Certificate of Appropriateness

2618 N. HACKETT AV. Downer Avenue Historic District

PTS ID 114296 COA: replace storm windows

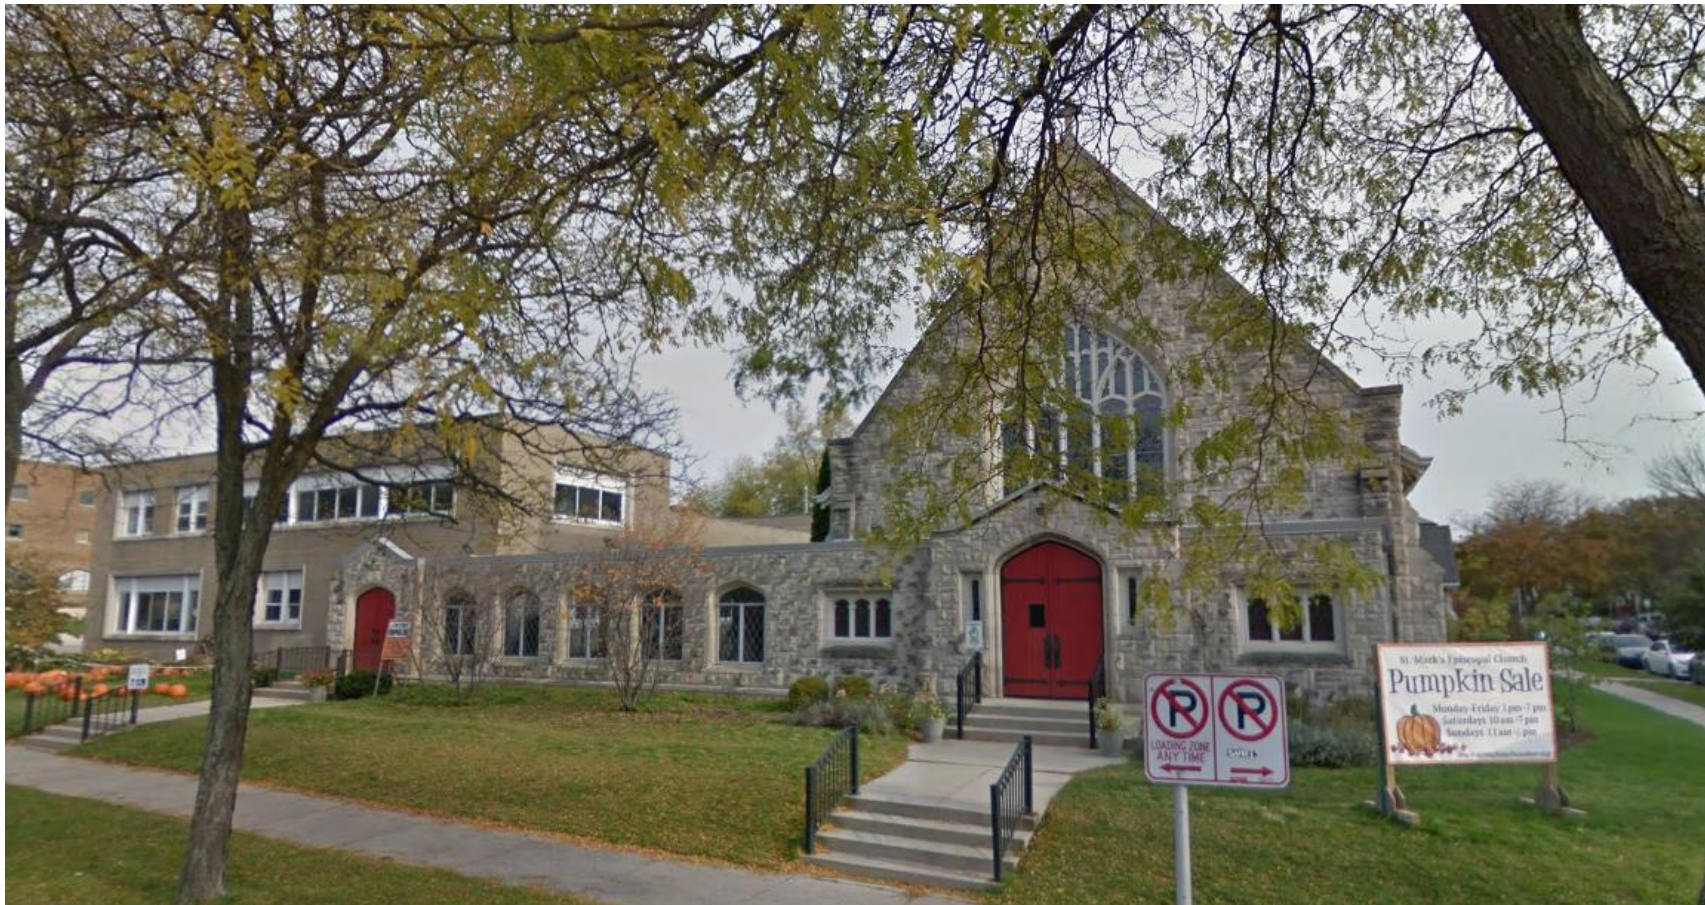
All metal portions of new storm windows must be painted to match surrounding trim paint or surrounding stone. If there are storm windows that have not yet been manufactured, a factory paint finish or powder-coating can be used, however, a consistent appearance should be used on each face of the building, i.e., only one type of finish over the metal per elevation of the building.
